**City of Miami
Planning Department
Historic Preservation Office**

ANALYSIS FOR A SPECIAL CERTIFICATE OF APPROPRIATENESS

FILE ID: PZ-24-18725

PROJECT ADDRESS: 67 NE 44 ST

Proposed Rendering

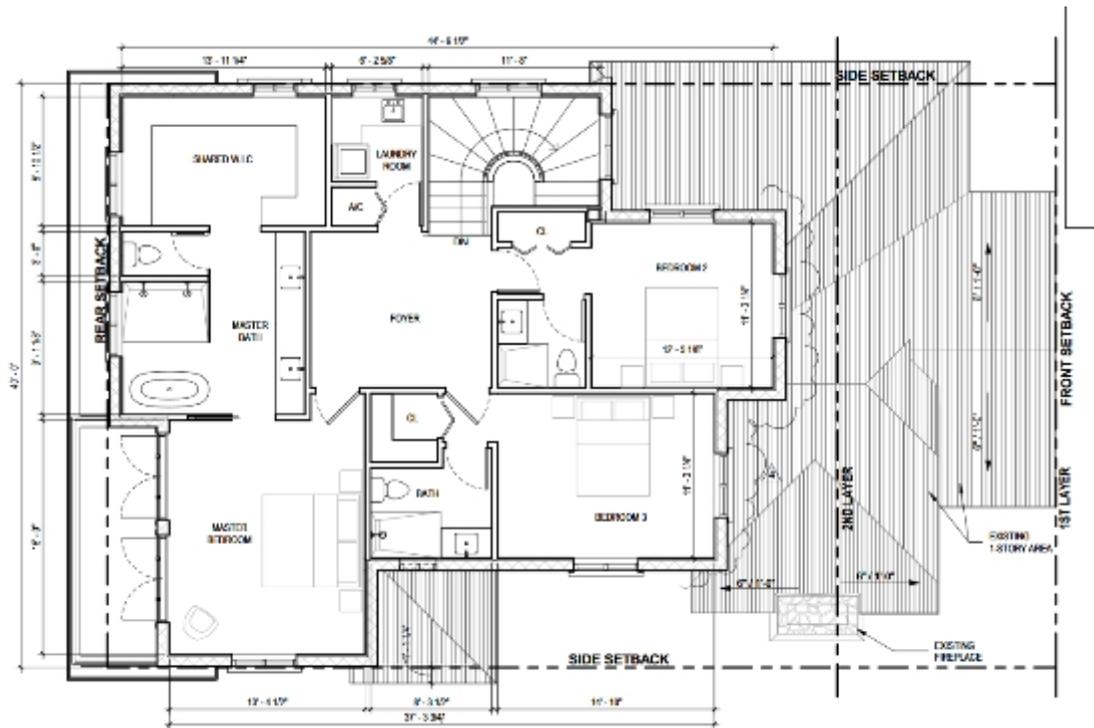
- Form – The proposed undertaking will alter the primary structure’s form and overall mass by adding a second story. The second-floor massing is set back to differentiate between the historic and the new. To break up the massing, one of the bedrooms was set further back. A cantilevered roof was added as a carport to further incorporate different volumes. The proposed addition remains overwhelming to the original structure.

- Height – The proposed undertaking will add considerable height to the structure. The height of the new addition does not keep with the context of the bungalow style and would overwhelm the adjacent structures.

- Revisit window height in relation to the roofline to include appropriate spacing/context
- Clarify windows of stairs
- Windows should be more uniform in size and placement
- Revisit the ground floor guest room, as original plan will split the window
- Retain the front (window and front entry should not be switched)
- Request for section drawings to illustrate new vs old

- Reducing to better massing
- Retain fenestration on façade, use as guide for placement and sizing of other windows
- Revisit height(s) of the interior
- Include dimensions showing interior and exterior heights

- Windows no longer touch the roofline
- Window over staircase is on the second floor; floor plan and elevation match
- Windows are more uniform, placement is apt
- The guest room on the ground floor has been changed into an office, and the half-bathroom has been moved away from the exterior wall
- The front is retained (window and front entry remain in original locations)
- Broke up the massing of the second-floor facade by recessing Bedroom 3
- Added a cantilevered roof extending over the driveway for variety of massing
- Fenestration on façade are uniform in size and placement
- Revisited the heights of the interior to bring the 'top of peak' from 29'-9 7/8" to 27'-11 1/8"
- Dimensions are included on the elevation renderings

- Windows on side elevations are not a uniform size, but correspond to the interior uses and are not overtly irregular
- Column with coping on front porch is not included in drawings but is also not explicitly listed as being removed/demolished
- No section drawings
